Recall Bulletin

PRODUCT SAFETY RECALL

SUBJECT: SECOND ROW CENTER SAFETY BELT

**MODELS: 2003-2005 CADILLAC ESCALADE, ESCALADE ESV, ESCALADE EXT
 2003-2005 CHEVROLET AVALANCHE, SILVERADO CREW CAB,
 SUBURBAN, TAHOE
 2003-2005 GMC SIERRA CREW CAB, YUKON, YUKON XL
 2004-2005 HUMMER H2**

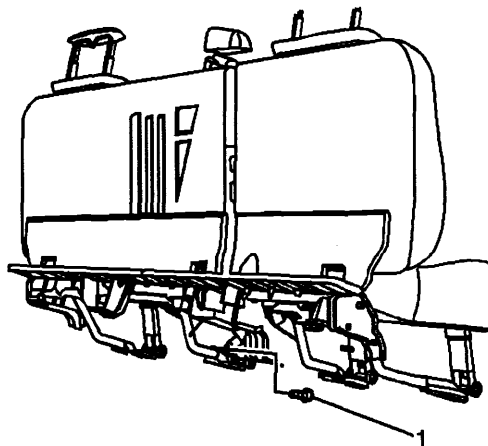
General Motors has decided that a defect, which relates to motor vehicle safety, exists in **certain** 2003-2005 Cadillac Escalade, Escalade ESV, Escalade EXT; Chevrolet Avalanche, Silverado Crew Cab, Suburban, Tahoe; GMC Sierra Crew Cab, Yukon, Yukon XL; and 2004-2005 HUMMER H2 vehicles. On these vehicles, the seat loop in the second row center seating position may make it difficult to position the lap portion of the safety belt low around the hips of the occupant. In the event of a vehicle accident, if the lap portion of the safety belt routing is not low and snug on the hips, it may not properly restrain the occupant and could increase the risk of abdominal injury.

Dealers are to eliminate the seat loop by removing the safety belt from the loop and stitching the loop closed.

811814

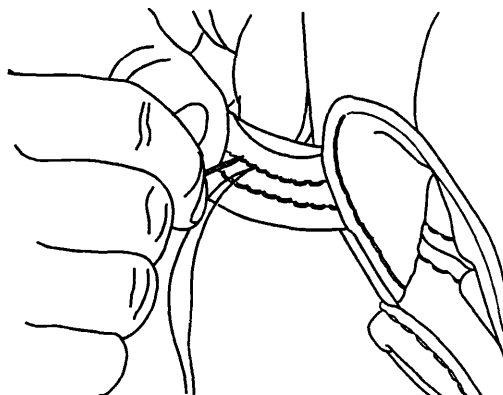
4. Remove the nut (1) retaining the rear center seat's lower seat belt anchor (seat back shown in the up position).
5. Remove the belt anchor point from the stud.
6. Remove the belt from the seat loop on the front of the seat back cushion.
7. Route the belt outside of the seat loop and install it on the lower anchor stud. Be sure that the belt is not twisted.
8. Install the retaining nut to the anchor stud.

Tighten the retaining nut to 53 N·m (39 lb ft).
